ADDENDUM

Campus HVAC System Upgrade
Horace Mann Elementary School
Bakersfield City School District
District Project No. 22214.00-32.32
566-0016
DSA No. 03-122671

Date: May 6, 2024

Subject: Addendum #001

Campus Site Plan
Scale: 1" = 40'-0"

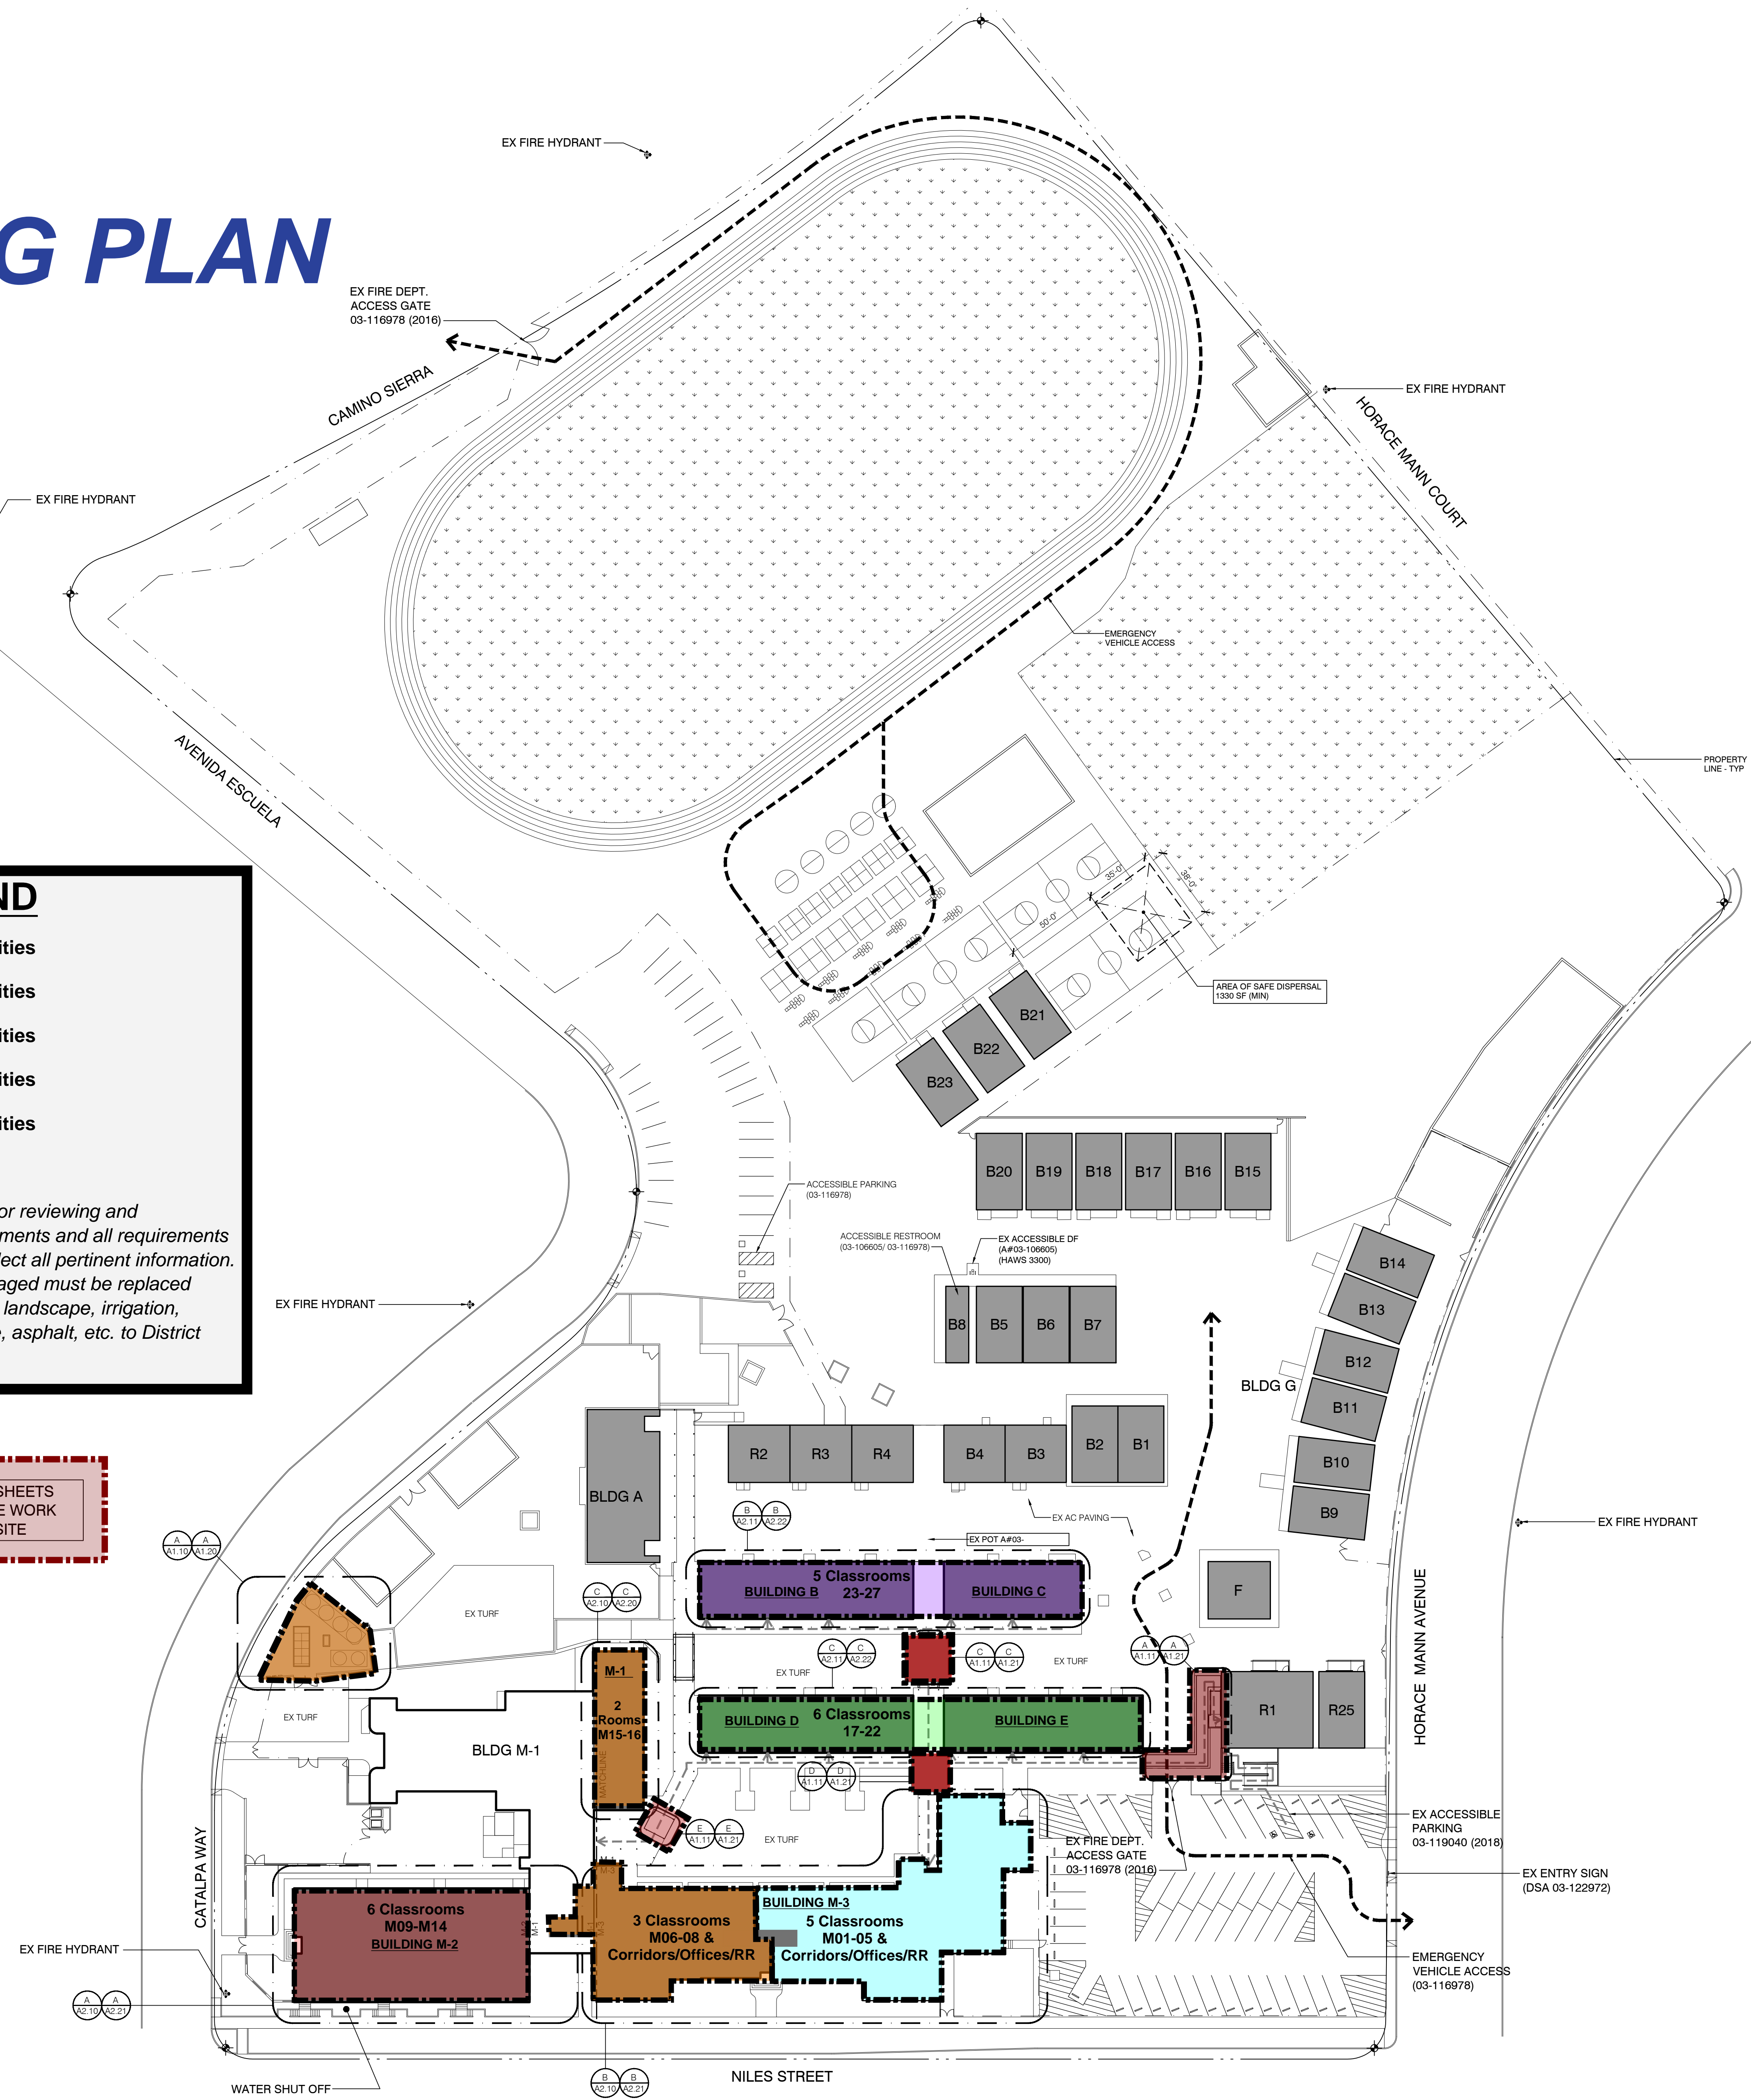
- 1.11.1 Revise detail references on Campus Site Plan at Equipment Yard to read as follows:
A/M1.00 in lieu of A/1.10
-/E1.00 in lieu of A/1.20
1.11.2 Add General Site Plan Note to Campus Site Plan as follows:
GENERAL SITE PLAN NOTES:
1. REFER TO DEMOLITION FLOOR PLANS FOR ADDITIONAL INFORMATION ON DEMOLITION PATCH/ REPAIRS AT MECHANICAL EQUIPMENT AND COMPONENTS REMOVAL.

ADD-001.01

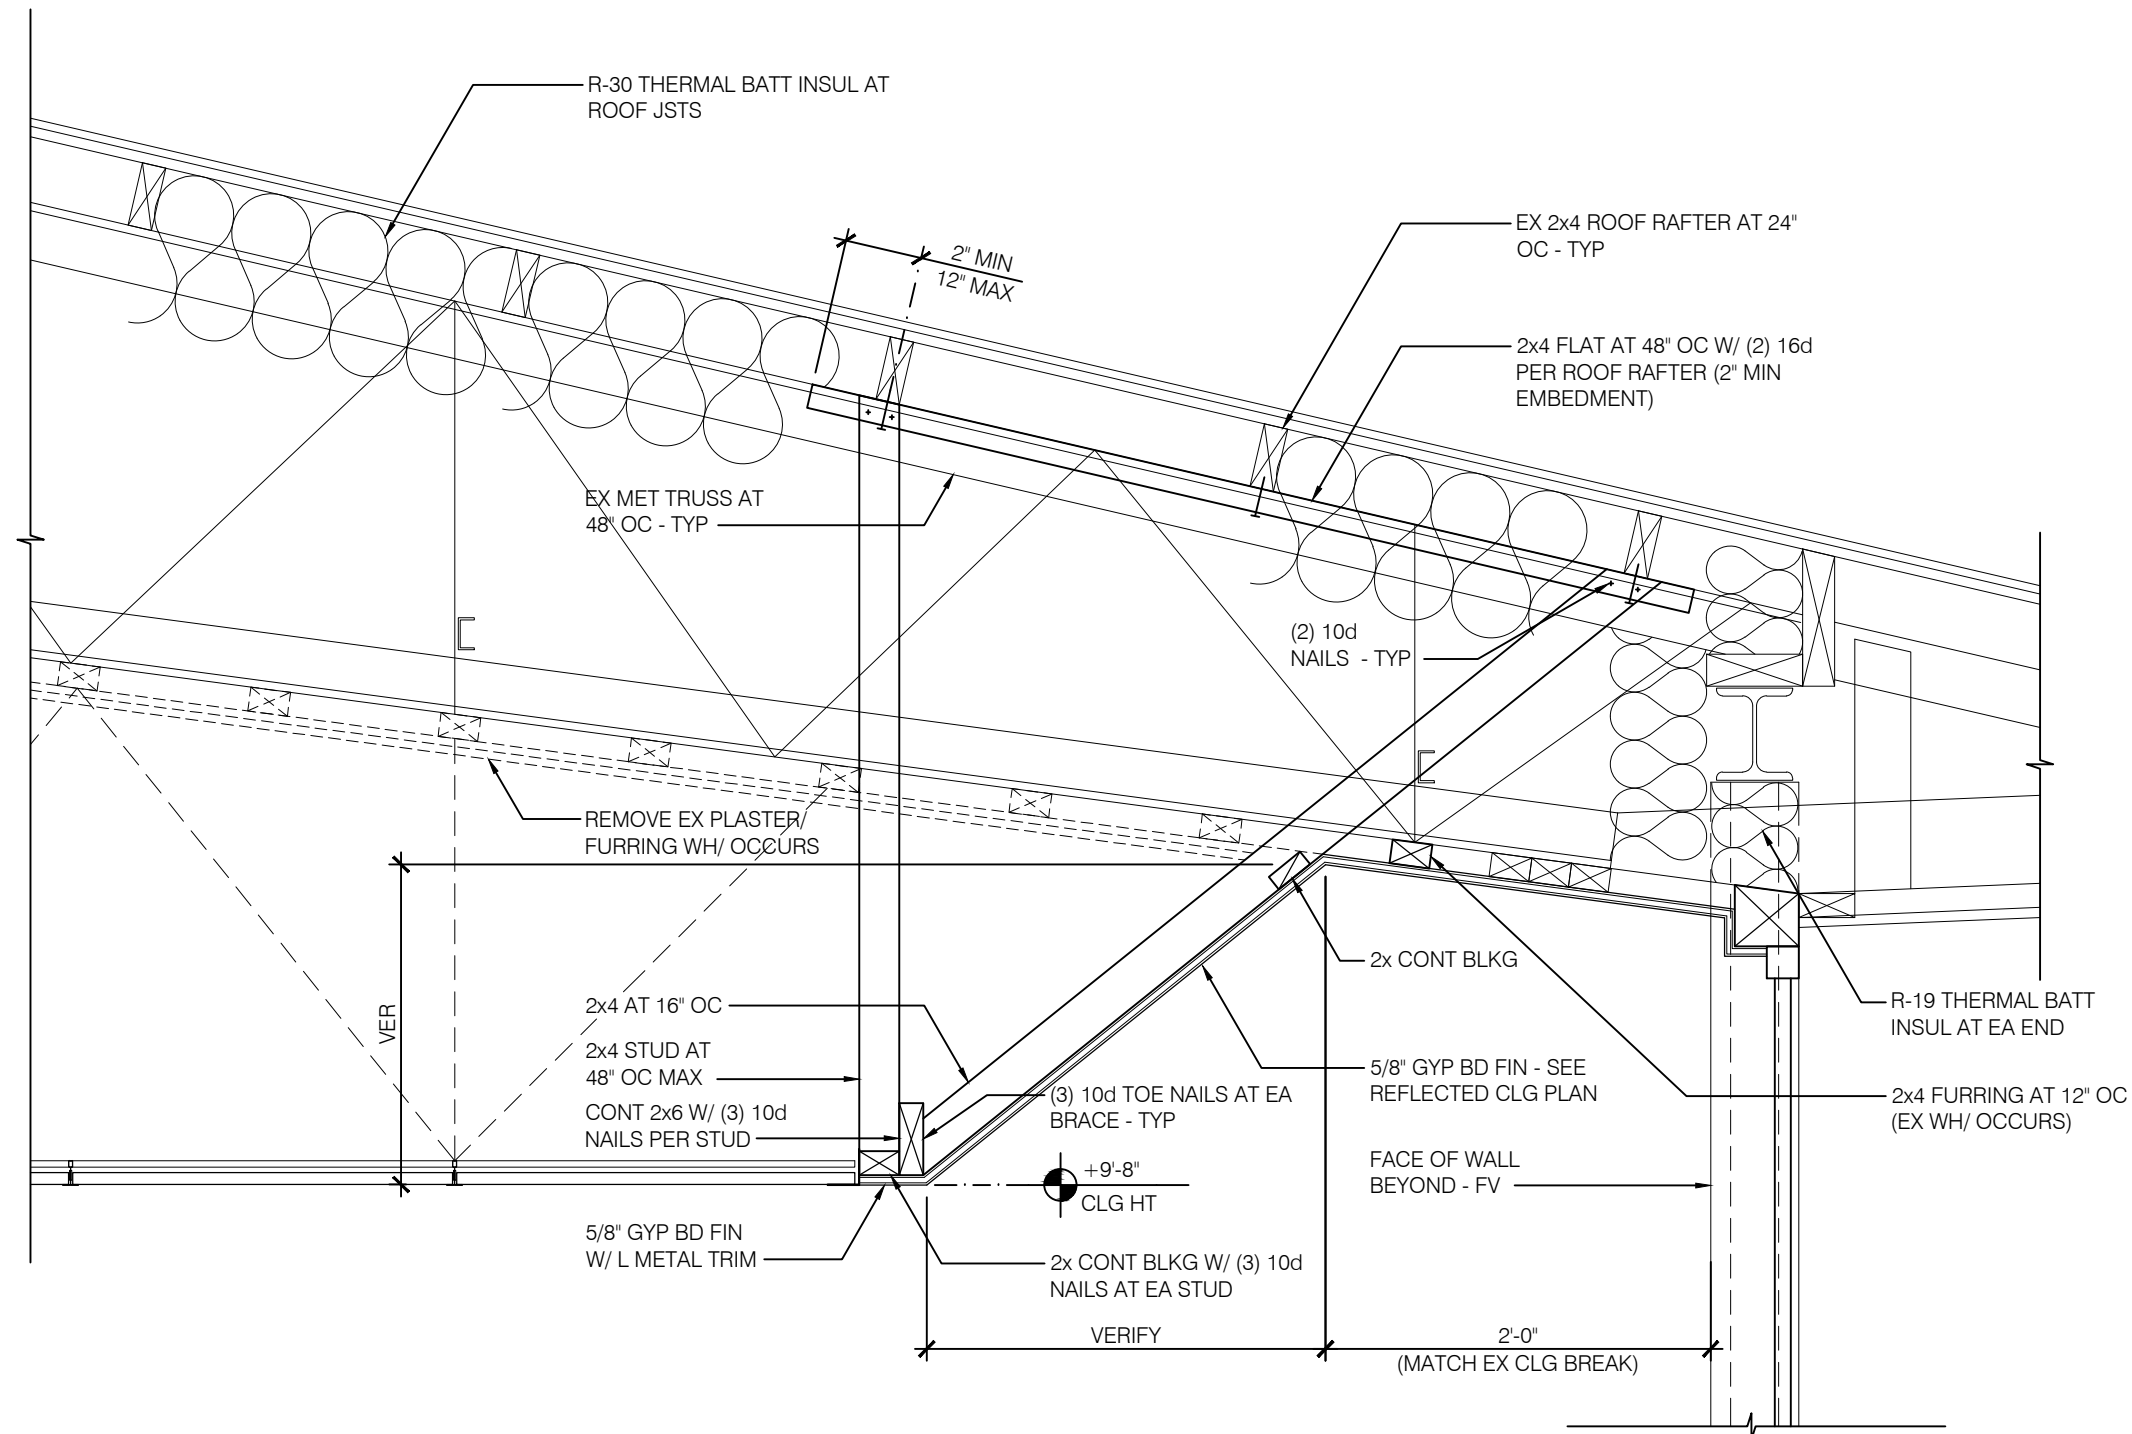
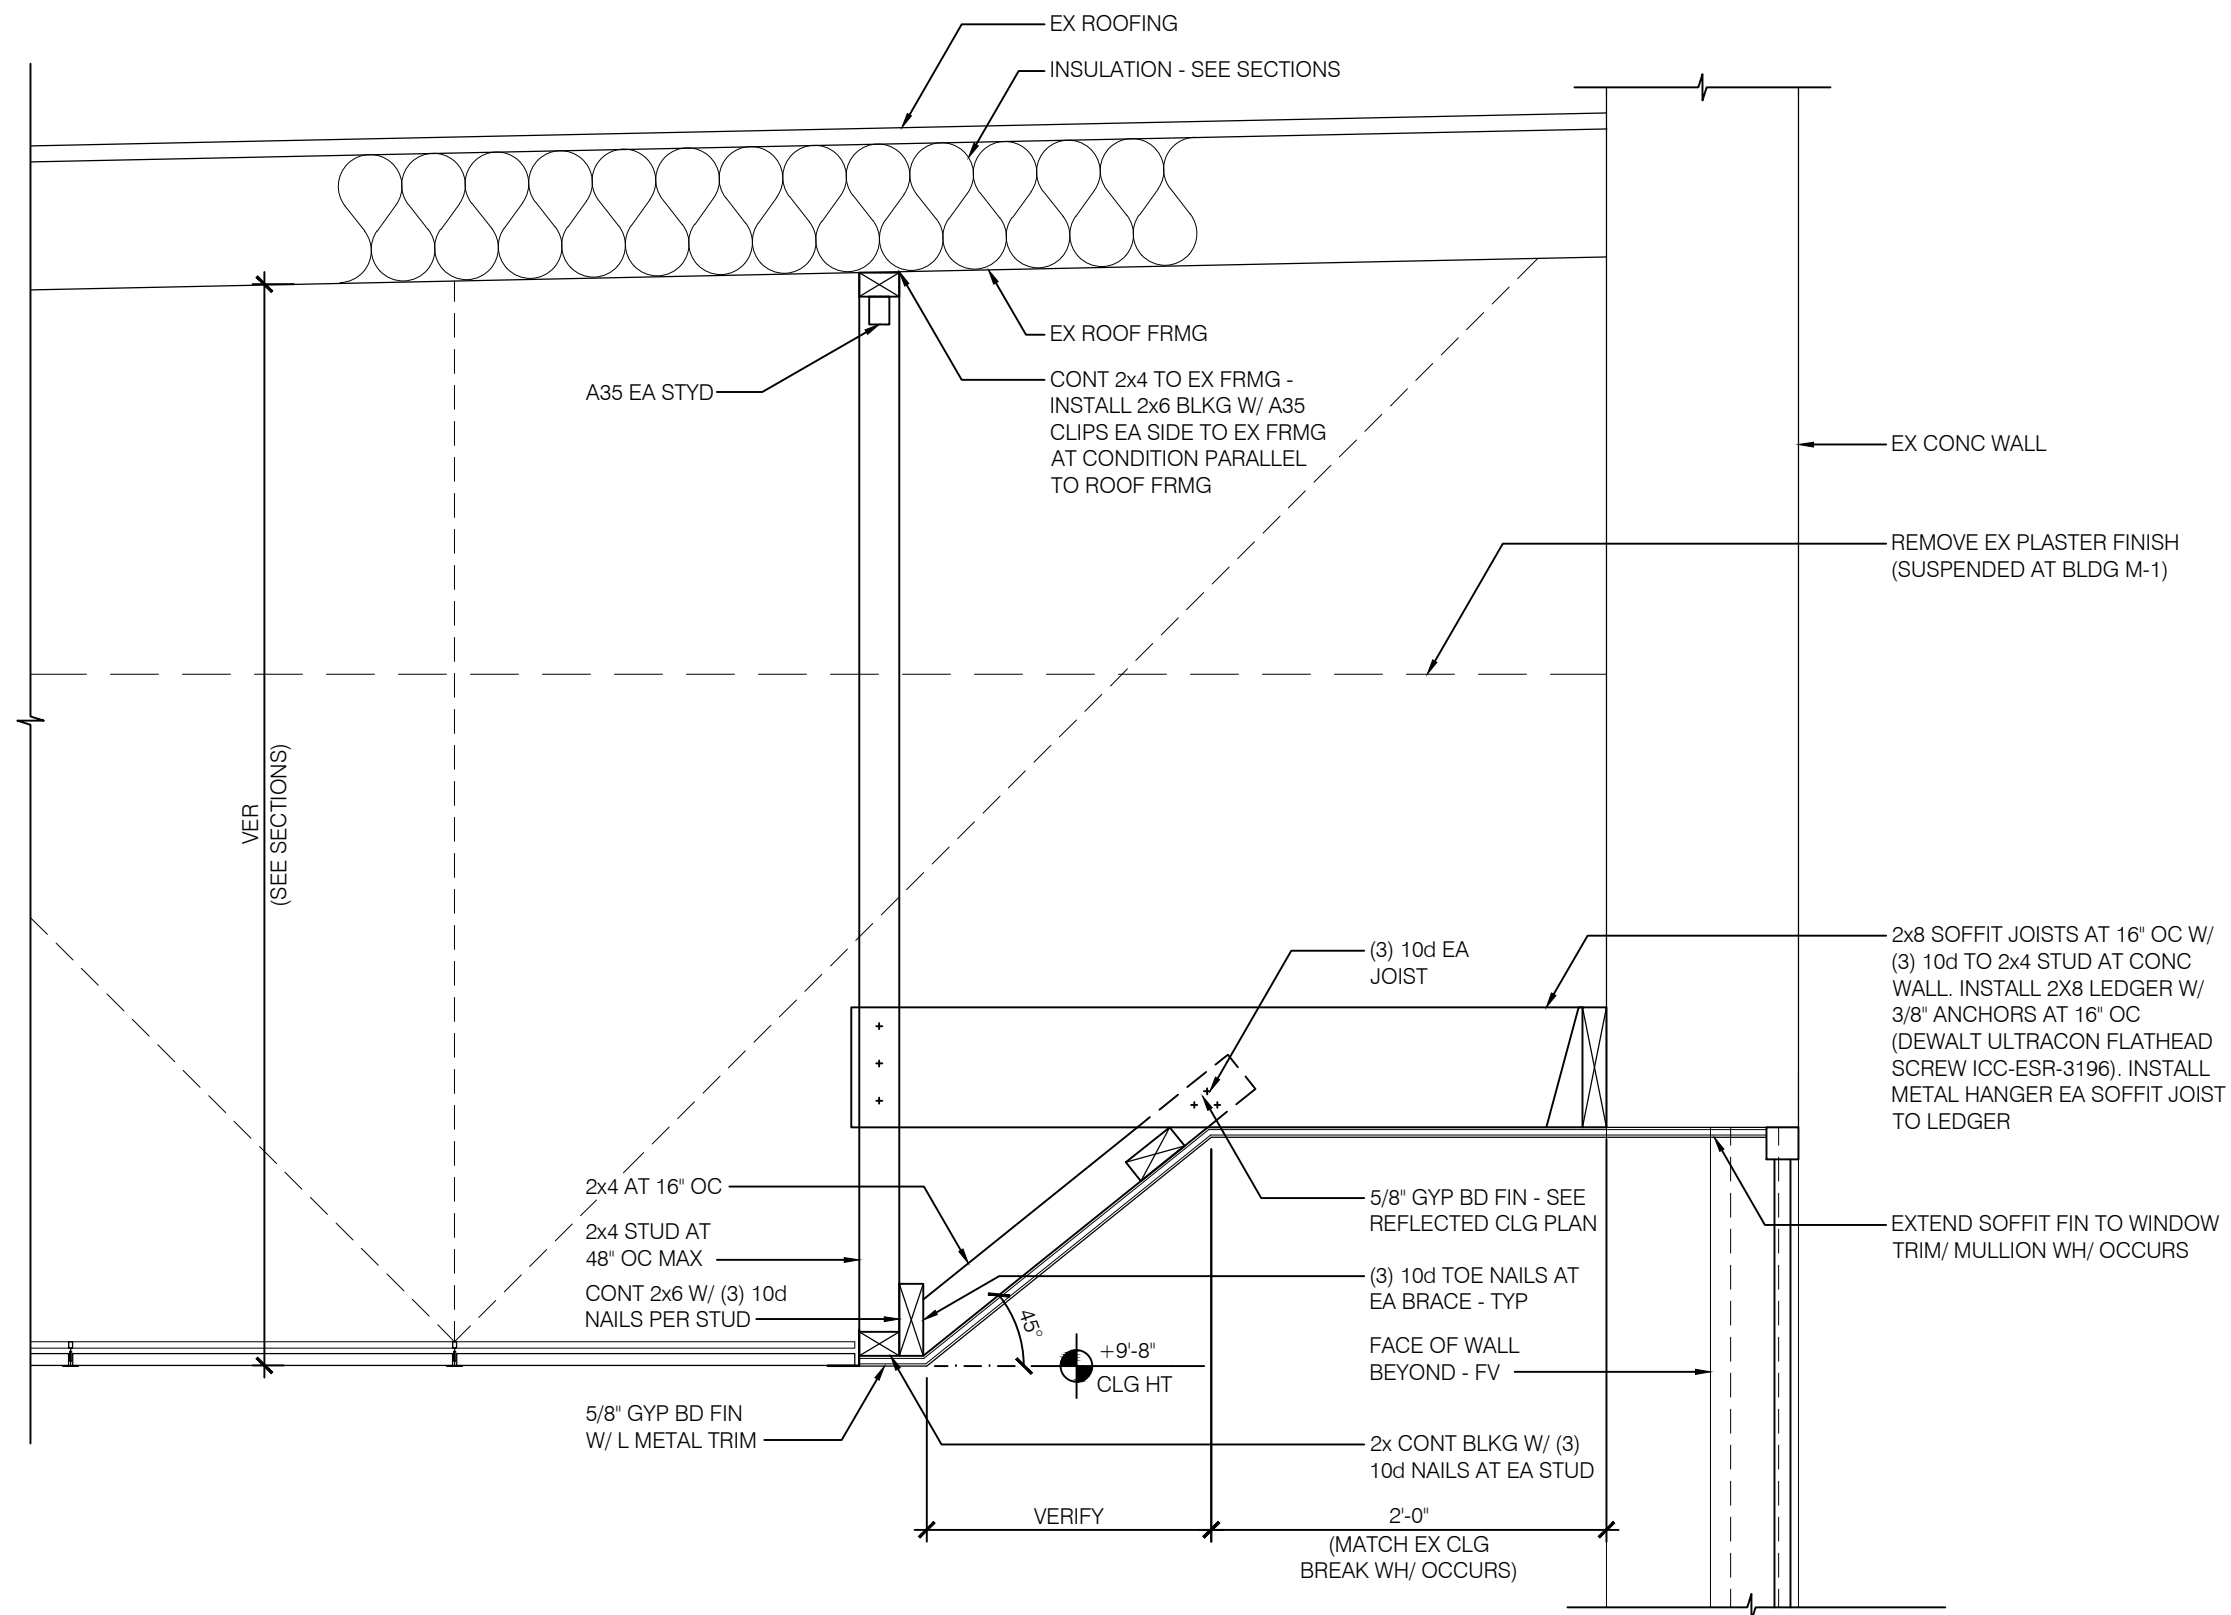
- 1.28.1 Add Detail 55 as indicated in attached Drawing ADD-001.01.
1.28.1.1 If window bid alternate is not taken (**Alternate #01**), use Detail 55/A8.01 at the following locations:

- 1.28.1.2 Adjust wall finish extent as applicable if Detail 55/A8.01 is used.
- 1.28.1.3 Adjust Ceiling finishes as applicable if Detail 55/A8.01 is used.
